Fwd: Cargill Closure Report and Permit Application

Becky - Please file this email and the attachments to 62-SDP-04-89. This email and the attachments address my request for information noted in Doc 109309. I will now issue the closure permit. Thanks.

Prior to meeting on site, Garden staked the location of survey point 35171. Upon arriving onsite, HR Green started to hand auger at that location. The land surface had vegetation on it and from the surface to a depth of 11-12" brown clay was observed. From this depth down to approximately 40" a medium brown to grey/brown stiff clay soil was observed. CCR was not observed within 40" of the ground surface at this location. The observations indicate that a depth of approximately 1' of vegetative cover (or loose fill) was placed on top of over 2' of clay cap material at survey point 35171. As there was sufficient thickness of clay cap material at this location, no step out locations were augered during this investigation.

**Site
Photographs**

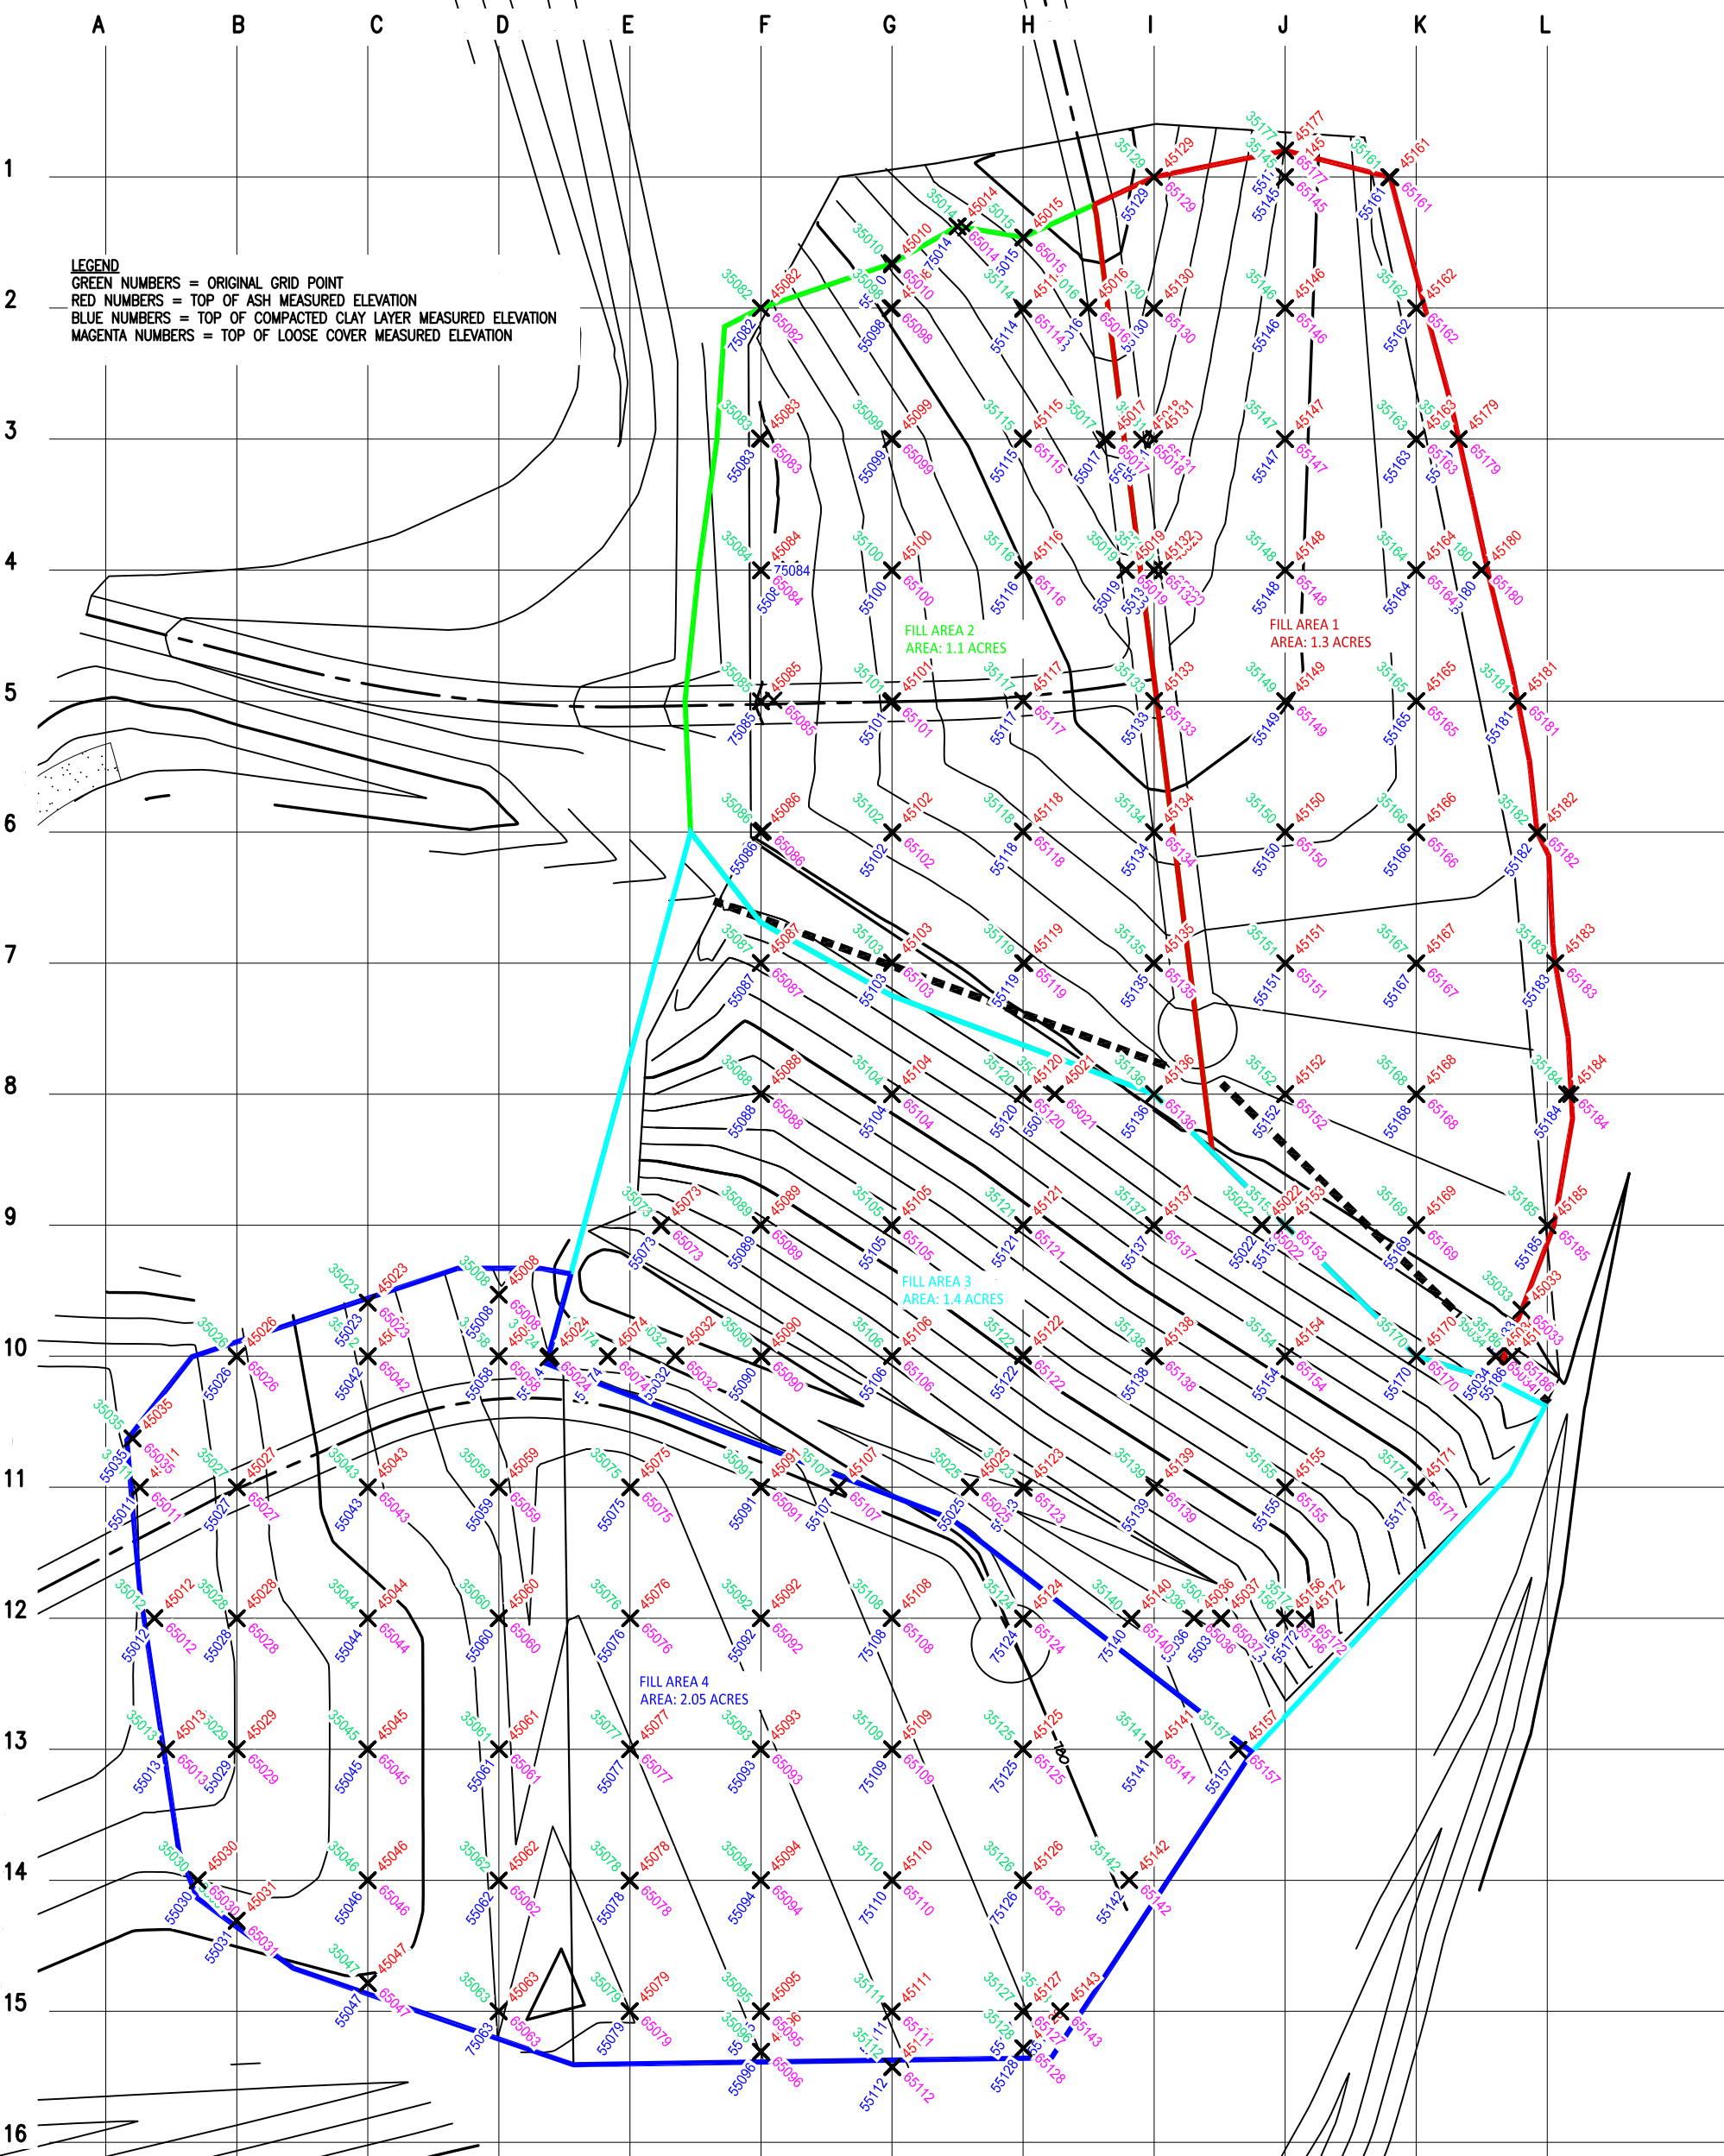
Thanks for setting up the call yesterday, Again, I apologize for the confusion that I have caused. 35171 is the only point short on compacted fill as the location lost 0.4' while placing the loose fill, which implies there is only 1.6' of compacted soil. As previously discussed, the other two points were considered deficient on loose fill as we considered placement of erosion stone as protection of the compacted layer or increasing the loose soil thickness. However, as you pointed out yesterday, 35146 is not deficient. But 35145 is still 0.44' of loose fill. But as agreed upon in our call, this point is in a previously closed and approved area, so we are not pursuing correction of the deficiency.

So the only point of concern is 35171 as it does not appear to have any loose fill and is deficient in the compacted fill thickness. Although this is close to the edge of the cap, the transition of the cap to the existing ground outside the waste boundary should not yet be occurring. Further, IAC does not allow for a deficiency in thickness. However, we recognize this is a localized issue and agreed to allow the permit holder to evaluate the permeability of this area versus the entirety of the cap as the intent in IAC for the compacted fill is limiting infiltration. It is recommended that the permit holder submit this analysis informally to the DNR for consideration. If we agree with the analysis and the results, a more formal response may be requested.

Even if this is acceptable, the loose fill thickness is deficient. Therefore, the placement of erosion stone or other material as protection of the compacted layer or to increase the loose soil thickness is needed. Please also include the proposed remedy in the informal submittal.

Attached to this memo are photographs of the soil that was observed in the boring, the stake with elevation information, and the ground surface at the time of completion of field activities.

View of 35171 stake with markings by Garden.

View of back of 35171 with ground elevation by Garden.

View of soil in boring with transition from vegetative cover to clay cap in auger.
